EPA-SAB-xx-xxx

Subject: Transmittal of the Final Science Advisory Board Report: *Review of the Science Supporting the Proposed Rule Titled, New Source Performance Standards for Greenhouse Gas Emissions From New, Modified, and Reconstructed Fossil Fuel-Fired Electric Generating Units; Emission Guidelines for Greenhouse Gas Emissions From Existing Fossil Fuel-Fired Electric Generating Units; and Repeal of the Affordable Clean Energy Rule (RIN 2060–AV09).*

DRAFT Science Advisory Board Report: *New Source Performance Standards for Greenhouse Gas Emissions From New, Modified, and Reconstructed Fossil Fuel-Fired Electric Generating Units; Emission Guidelines for Greenhouse Gas Emissions From Existing Fossil Fuel-Fired Electric Generating Units; and Repeal of the Affordable Clean Energy Rule (RIN 2060–AV09)*

Figure 2. Data Inputs and Outputs for the BenMAP-CE Model.

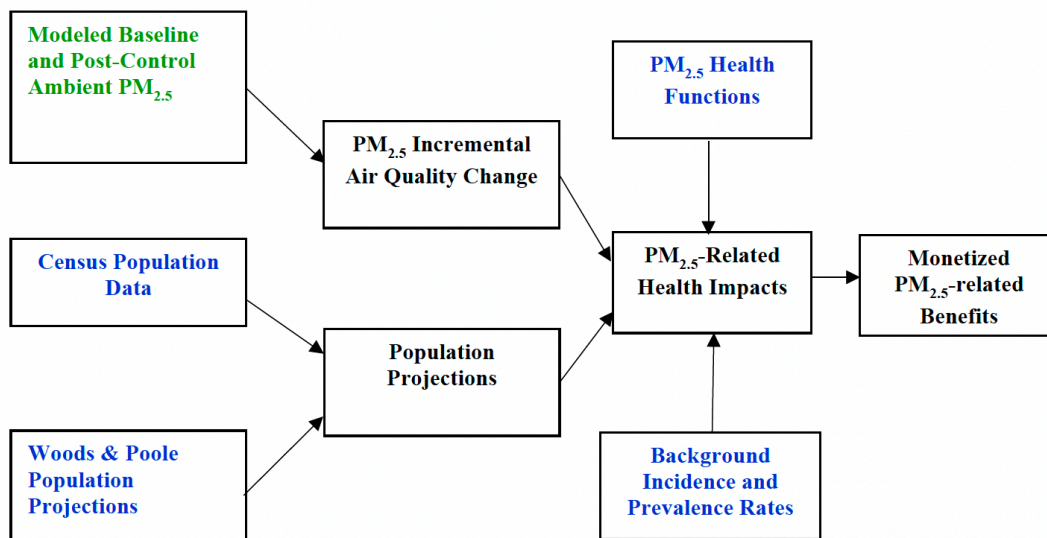
The core data sets for the modeling are described in Figure 2 and their origins are well documented: the U.S. Census, population projections from Woods & Poole, and the baseline incidence and mortality rates in the BENMAP-CE model, which are documented in Table 12 of

the RIA and the Executive Summary should be revised to do a better job of describing how the various components and data sets are utilized and integrated. The handling of uncertainty should be bolstered to more fully explore the assumptions and attendant uncertainties covered on pages 4-38 and 4-39 of the RIA. An expanded discussion should address how the uncertainties covered by the assumptions made could affect the magnitude and direction of the estimates of health benefits.

Figure 2 outlines the framework for estimating the monetary benefits of reducing the adverse effect of PM_{2.5} and ozone. The modeled changes in pollutant concentrations under the three scenarios are estimated with CAMx and combined with a risk function, derived from epidemiological investigations, to calculate the changes in attributable numbers of events using BENMAP-CE. The cost estimates are based on use of willingness to pay figures derived from the literature.

This approach to setting out sources of uncertainty and their consequences results in an incomplete presentation of the actual ranges of values associated with the estimates of morbidity and mortality events and the cost benefits. The confidence intervals inherently understate the true range of values consistent with the uncertainties in the input data. Errors in the exposure estimates are not propagated into the calculation of health and cost benefits. The tables should provide an appropriate caveat concerning interpretation of the 95% confidence
